Product Change Notice (PCN)

PCN Number: PCN-0460116R-01

Product(s) Affected: TB004-508 series

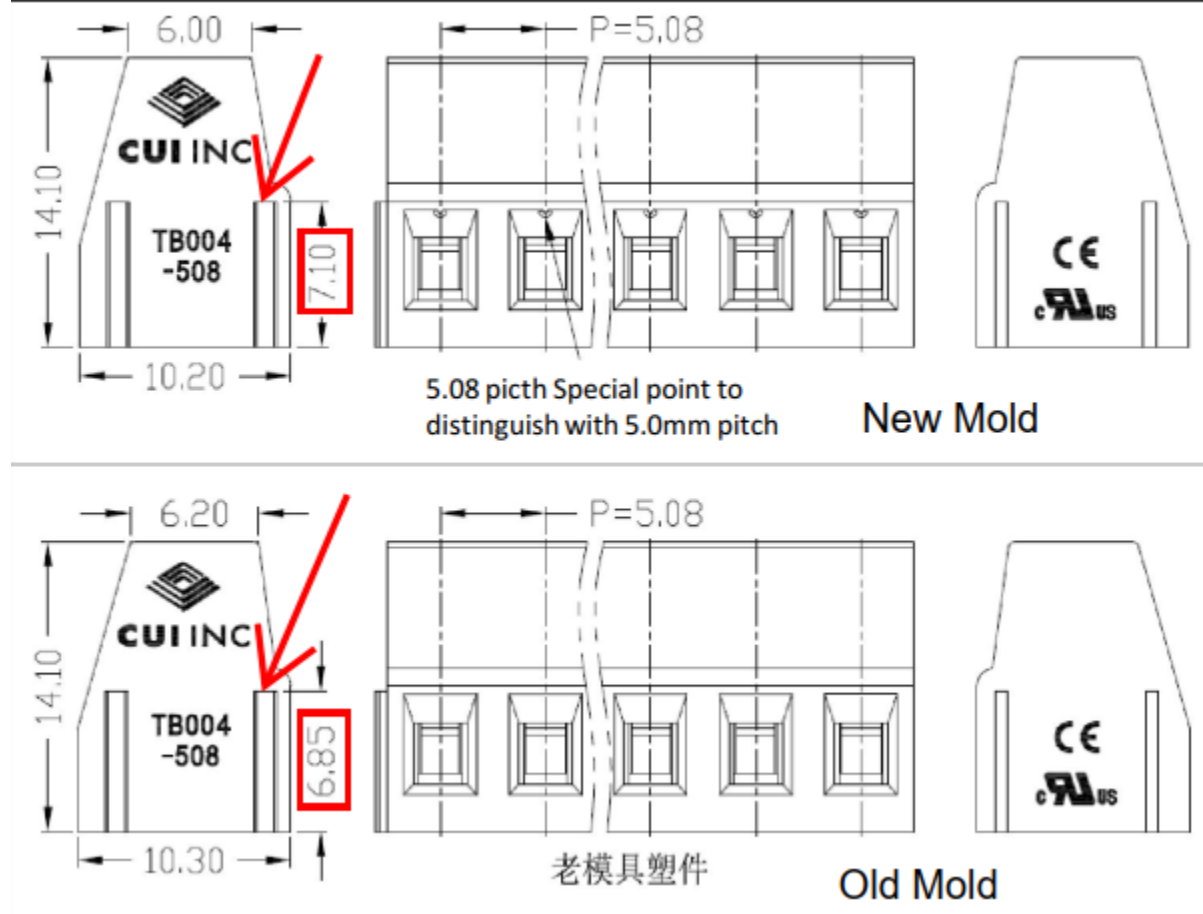
Reason(s) for Change: To promote the efficiency of automated assembly machine.

Description of Change: Adjusting slot height from 6.85mm to 7.1mm.
